ADDENDUM NO. 2

PROJECT TITLE:
REPLACEMENT OF BRIDGE NO. 06896, ROUTE 156 OVER ARMSTRONG BROOK

TOWN:
OLD LYME
 DRAWING TITLE:
GENERAL PLAN AND NOTES

TOWN:
OLD LYME
DRAWING TITLE:
ELEVATIONS AND LONGITUDINAL SECTION

PROJECT NO.
104-175
 DRAWING NO.
S-02
 SHEET NO.
04.02.A2

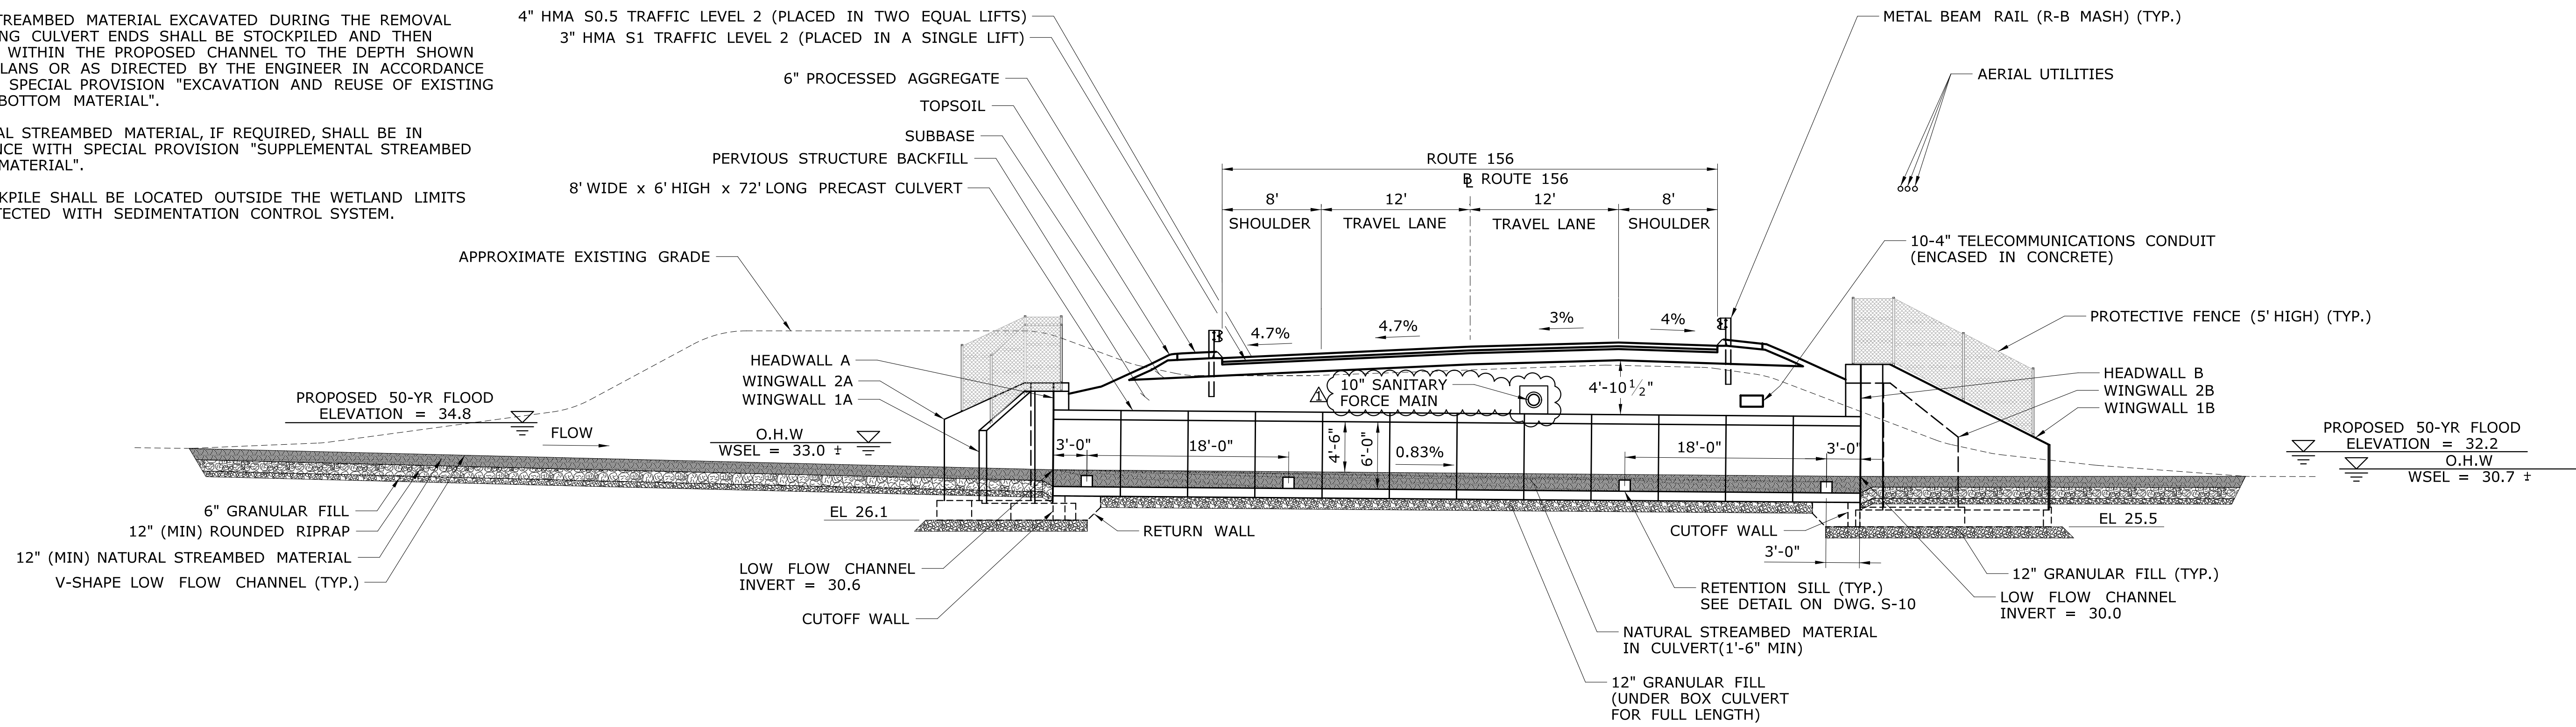
REV.	DATE	REVISION DESCRIPTION	SHEET NO.
1	1.31.25	ADD SANITARY FORCE MAIN	04.02

PROJECT NO.
104-175
DRAWING NO.
S-03
SHEET NO.
04.03.A2

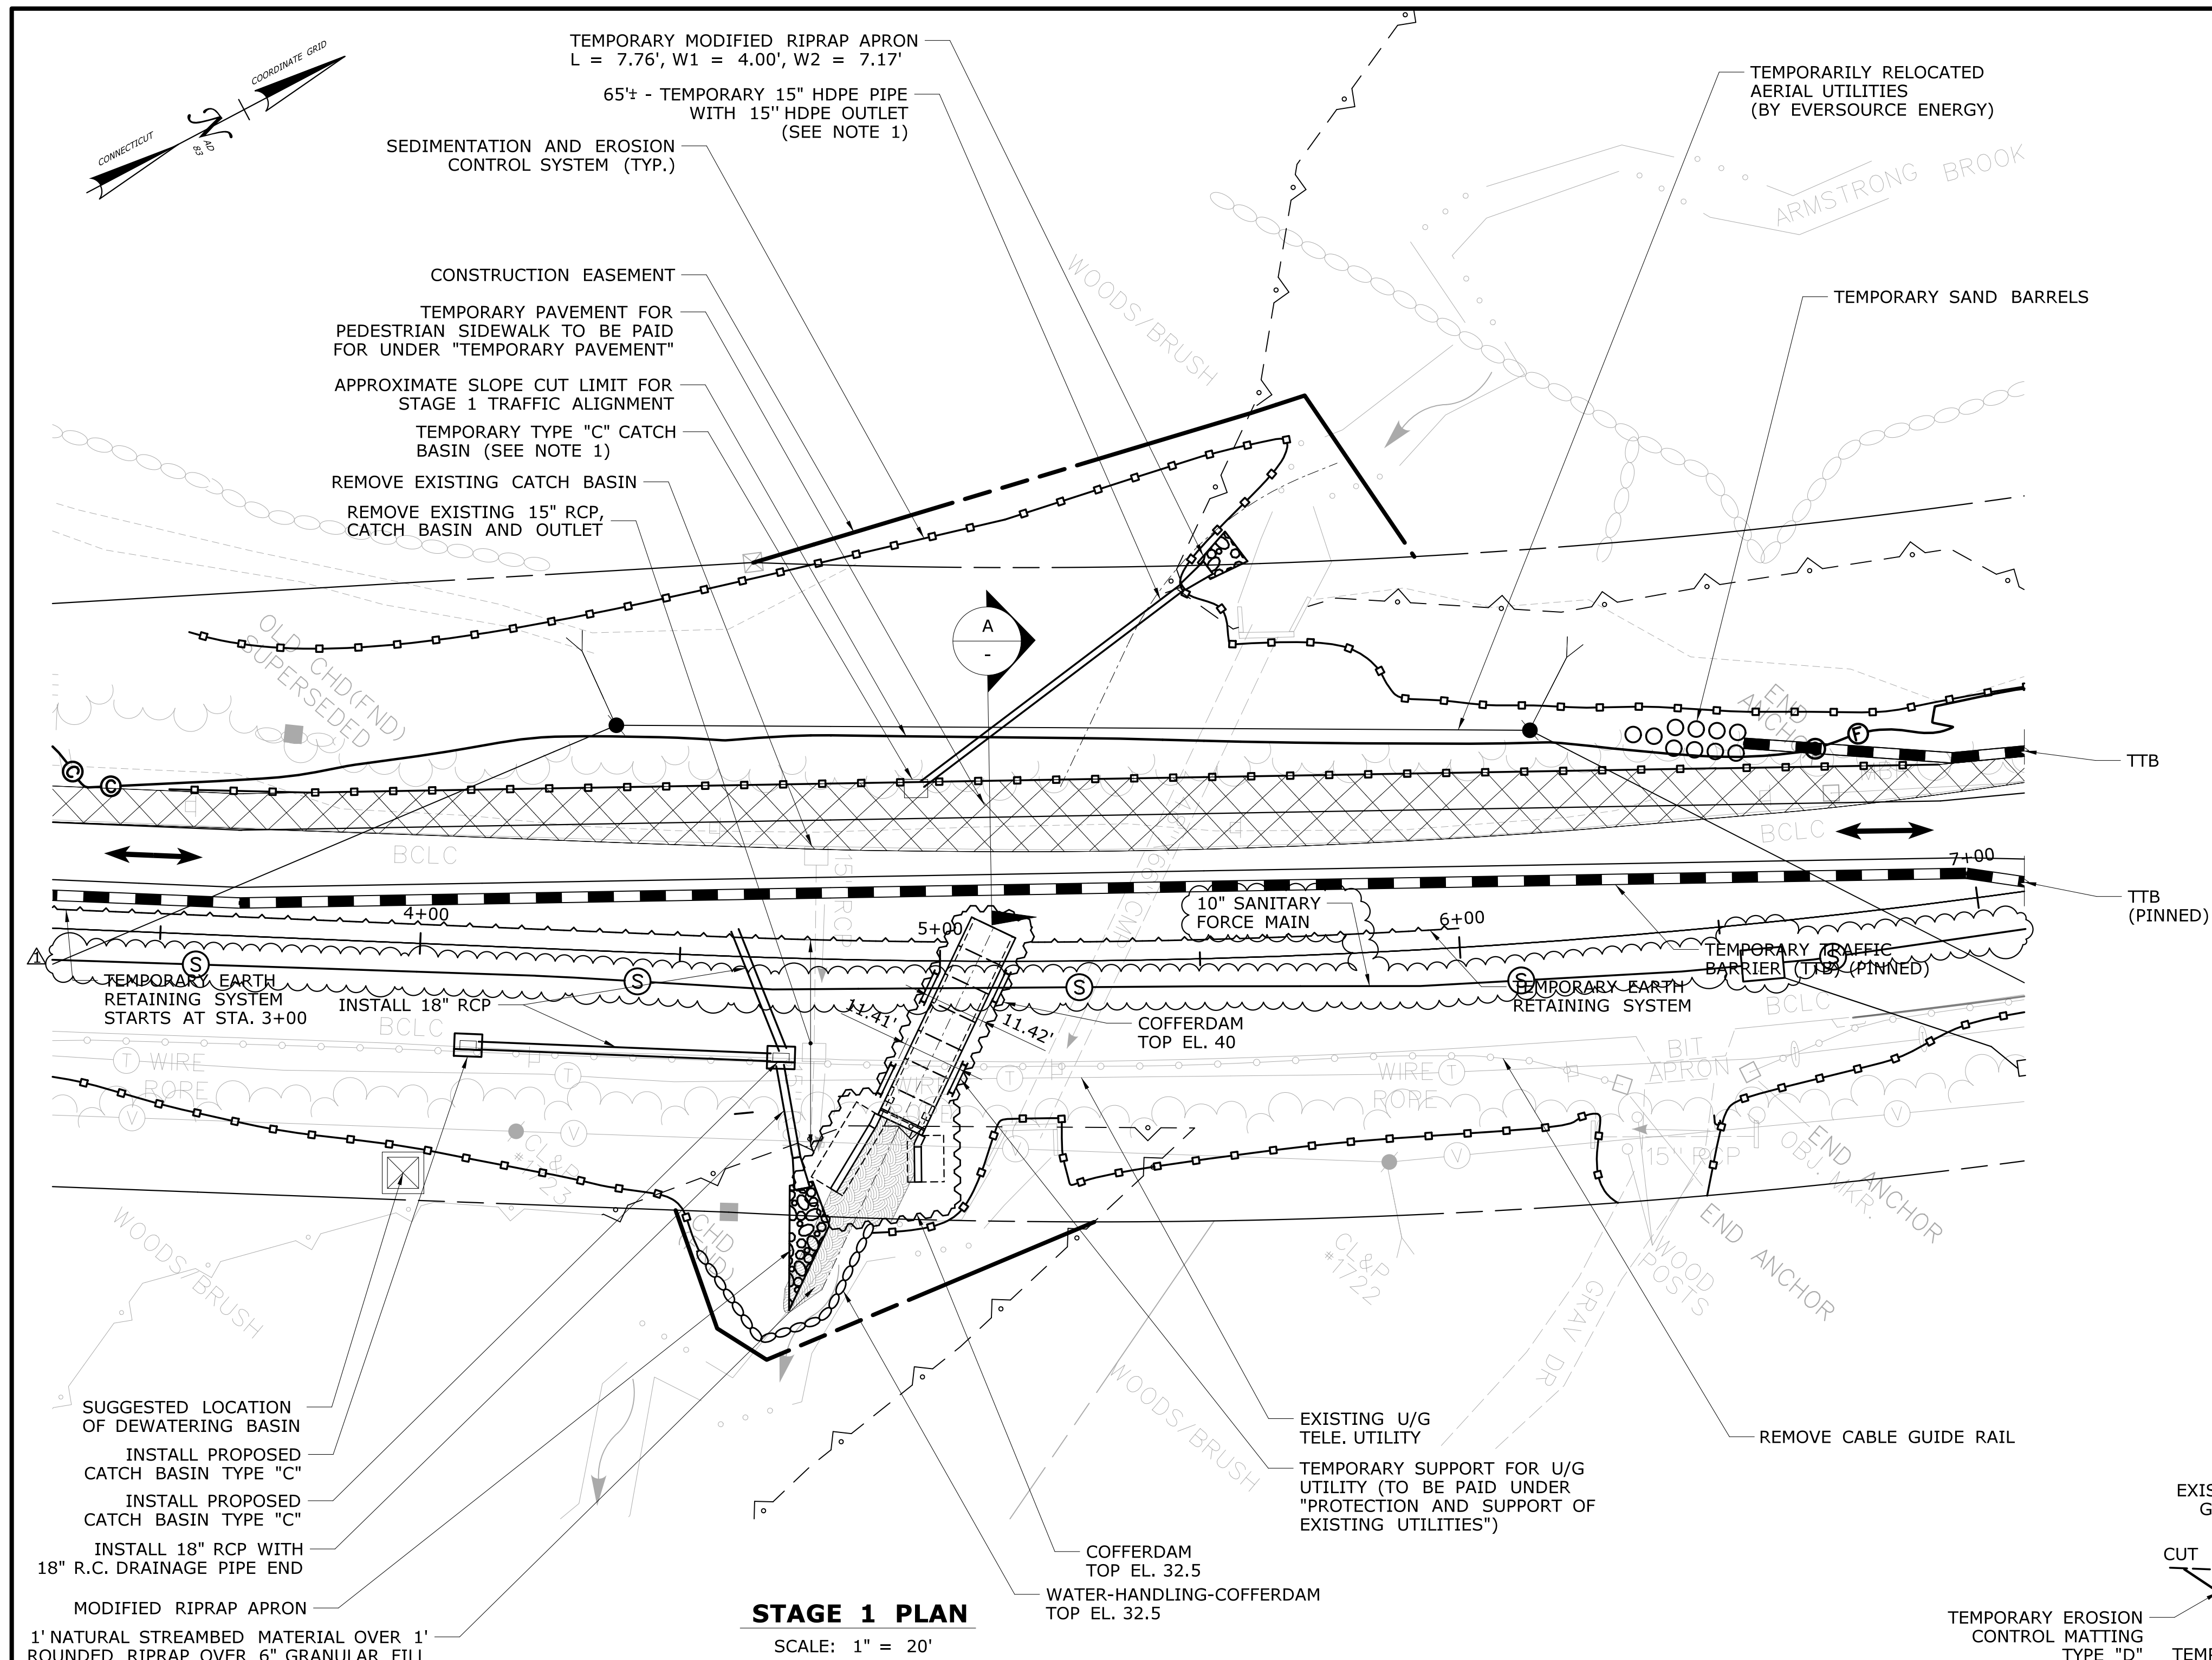
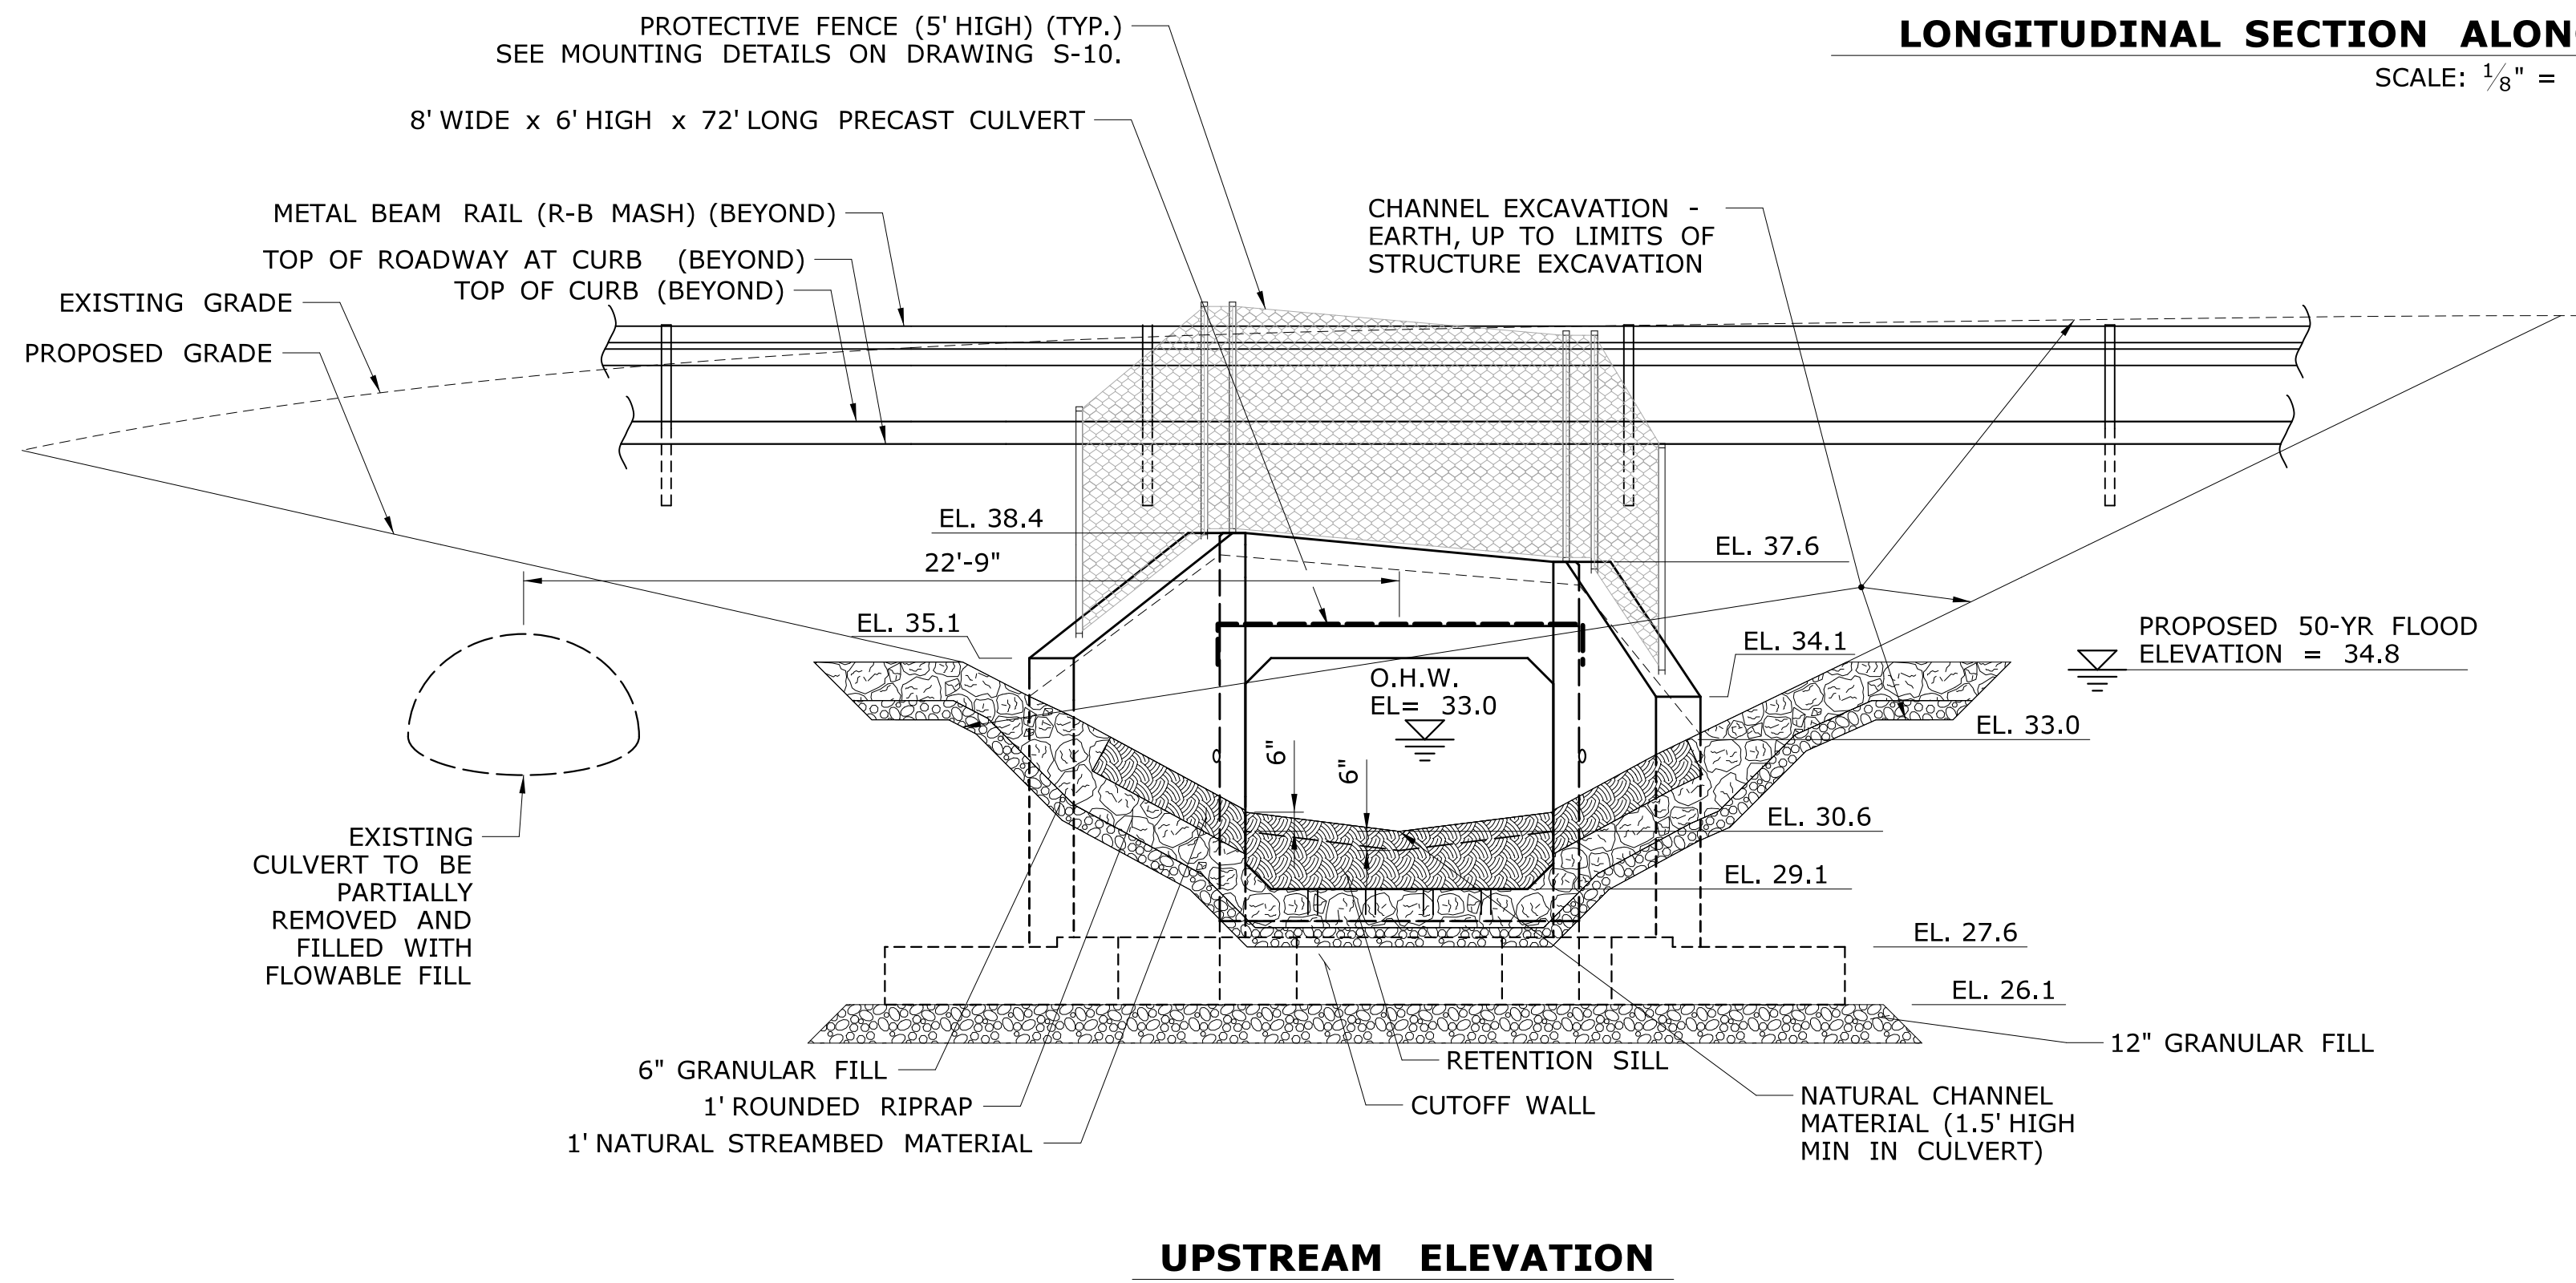
REV.	DATE	REVISION DESCRIPTION	SHEET NO.
1	1.31.25	ADD SANITARY FORCE MAIN	04.03
